BUILDING CODE OF AUSTRALIA ACCESS COMPLIANCE ASSESSMENT REPORT

PROPOSED LIGHT INDUSTRY COMPLEX

40 BRYANT STREET, PADSTOW

REPORT NO. ► 12991 Rev01

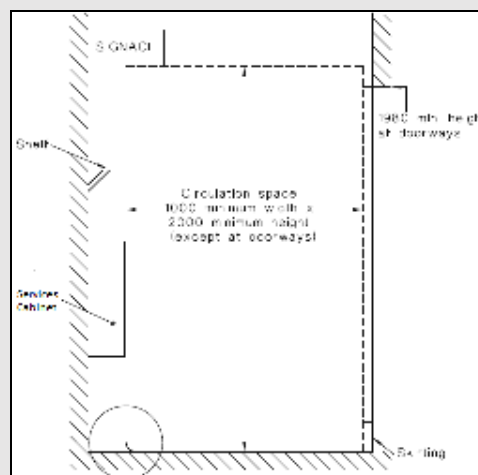
BCA DEEMED-TO-SATISFY PROVISION	COMPLIES	DOES NOT COMPLY	DESIGN DETAIL NA or Informational	COMMENTS
			X	<p><u>Performance Solution proposed at CC stage</u></p> <ul style="list-style-type: none"> The Level 01 and Level 03 Office spaces throughout the development are not accessible for a person with a disability, as they are accessed via a stairway, and not provided with a passenger lift or accessible ramp. <p>This non-compliance may be addressed via a suitable BCA Performance Solution at CC stage, noting the following:</p> <ul style="list-style-type: none"> Each individual Unit provides the equivalent function of a separate building; the occupants of the Office space in one unit have no direct association with occupants in an adjacent unit. As such, each Unit meets the equivalent DtS requirements of D4D4(f), which notes that a ramp or a passenger lift need not be provided to serve a storey (excluding the entrance storey), with a floor area of not more than 200 m²; and The incidence of people with a disability is expected to be relatively low, considering the nature of activities associated with an industrial complex; and Each unit includes spaces at the entry level which are capable of providing equivalent facilities that are accessible by people with a disability.  <p>X <u>Design requirements:</u></p> <ul style="list-style-type: none"> <u>Doorways:</u> All doors required to be accessible are required to comply with AS1428.1 Clause 13 requirements in relation to various items including: <ul style="list-style-type: none"> Door sill. Door hardware. Opening force required to operate the door. Luminance contrast.

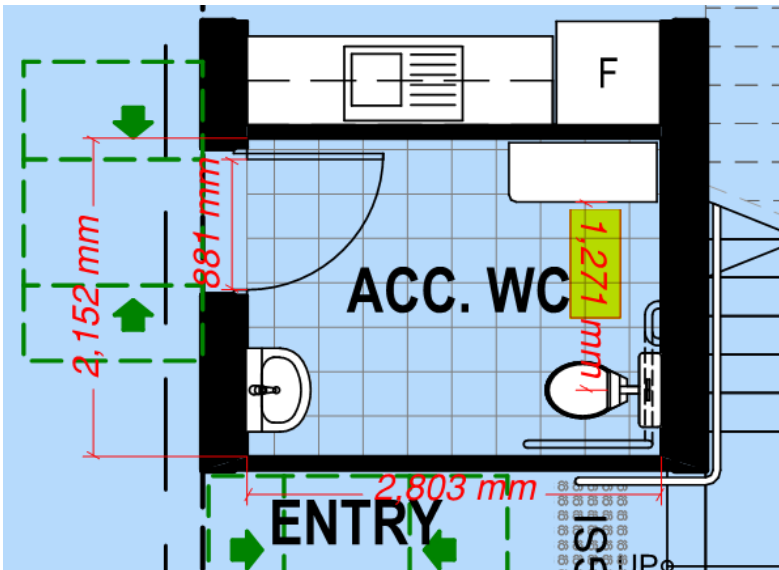
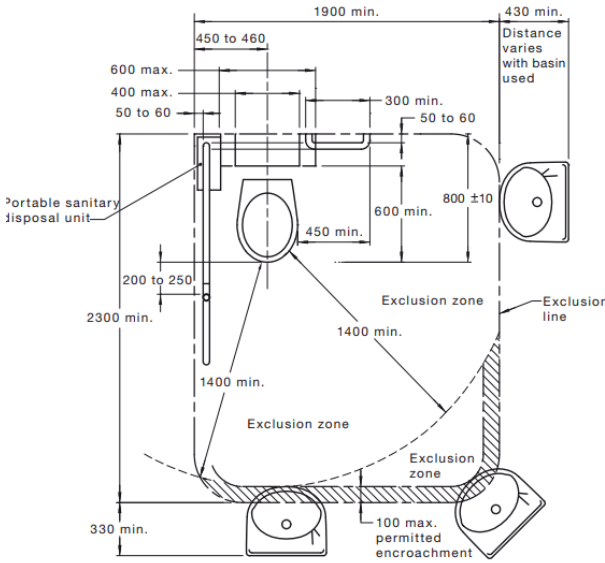
<p>F4D1</p> <p><u>Deemed-to-Satisfy Provisions</u></p> <p>[2019: F2.0]</p>				X	<p>(1) Where a Deemed-to-Satisfy Solution is proposed, Performance Requirements F4P1 to F4P6 are satisfied by complying with—</p> <p>(a) F4D2 to F4D12.</p> <p>(2) Where a Performance Solution is proposed, the relevant Performance Requirements must be determined in accordance with A2G2(3) and A2G4(3) as applicable.</p>
<p>F4D5</p> <p><u>Accessible sanitary facilities</u></p> <p>[2019: F2.4]</p> <p>In a building required to be accessible—</p> <p>(a) accessible unisex sanitary compartments must be provided in accessible parts of the building in accordance with F4D6; and</p>		X			<p><u>Does not comply</u></p> <ul style="list-style-type: none"> The proposed unisex Accessible sanitary compartments are not provided with sufficient circulation as required to comply with AS1428.1 requirements. <p>Due to an internal fixture which is assumed to be a shower seat, the toilet pan is not provided with a complying exclusion area of at least 1400mm. Unit 9 is shown below as an example, however a similar compliance issue occurs in all accessible WCs.</p>

BCA DEEMED-TO-SATISFY PROVISION	COMPLIES	DOES NOT COMPLY	NA or Informational	DESIGN DETAIL	COMMENTS
				X	<p><u>Design Requirements</u></p> <ul style="list-style-type: none"> Detail should be provided at CC stage to demonstrate provision of a Unisex Accessible Sanitary compartment compliant with AS1428.1 Clause 15 requirements, including provision of required grabrails, toilet pan and seat, backrests, circulation spaces, doors and door hardware, signage, fixtures and fittings including tapware soap dispensers, toilet paper dispenser, basins, and mirrors and disposal units (where installed). Light switches in unisex accessible sanitary facilities are required to comply with Clause 14.2, and located in accordance with Figure 37 (located 900- 1100mm above floor level). Rocker action and toggle switches shall be provided and have a minimum dimension of 30 mm × 30 mm. Push-pad switches shall have a minimum dimension of 25 mm in diameter. <p>The summary of requirements for accessible sanitary facilities is provided below following Part F4D6 to assist the project team during detailed design &/or construction.</p>
